**SILVERTHORNE TOWN COUNCIL MEETING
AGENDA FOR SEPTEMBER 23, 2015- 6:00 PM**

TO: Mayor and Town Council
THRU: Ryan Hyland, Town Manager *RH*
Mark Leidal, AICP, Assistant Town Manager *ML*
FROM: Matt Gennett, AICP, Planning Manager *MG*
DATE: September 18, for the meeting of September 23, 2015
SUBJECT: South Maryland Creek Ranch – Preliminary Plan for Subdivision
(PT2015-18)

Subject: South Maryland Creek Ranch - Preliminary Plan for Subdivision (PT2015-18)

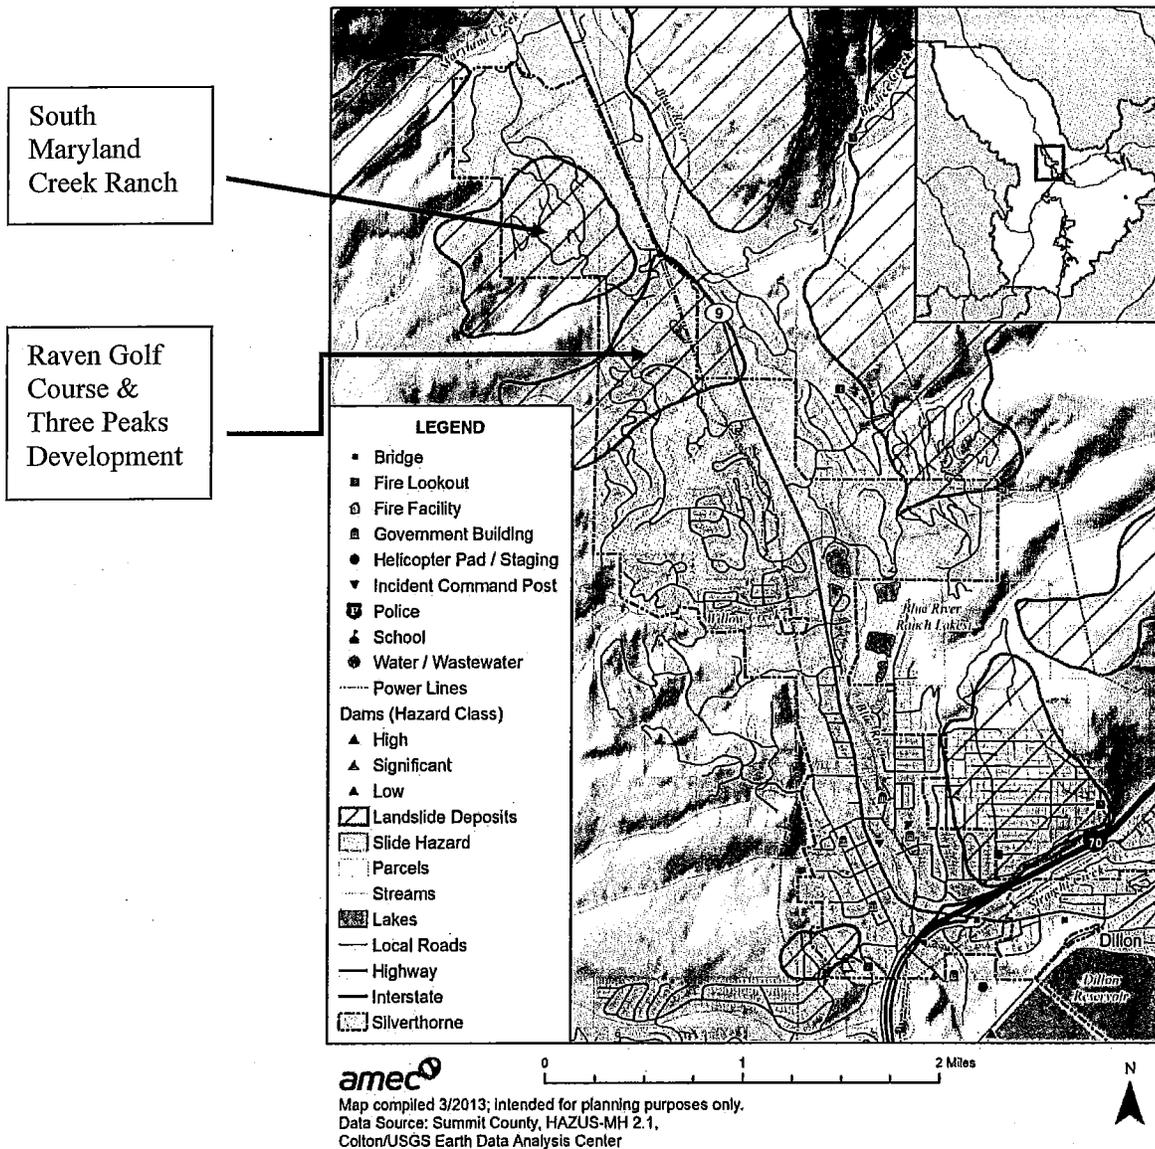
9. CGS Comment from July 7, 2014 Letter: *“Piezometer and inclinometer readings. It was CGS’s understanding in 2008 that the existing piezometers and inclinometers would continue to be monitored. CGS would like to review updated piezometer and inclinometer readings, to help characterize slope movement activity, failure surface depth, water levels, etc.”*

Response: Engineering Analytics (EA) provided additional piezometer data and inclinometer readings in their technical memorandum dated August 17, 2015. For completeness, the August 17, 2015 technical memorandum is provided in Attachment A.
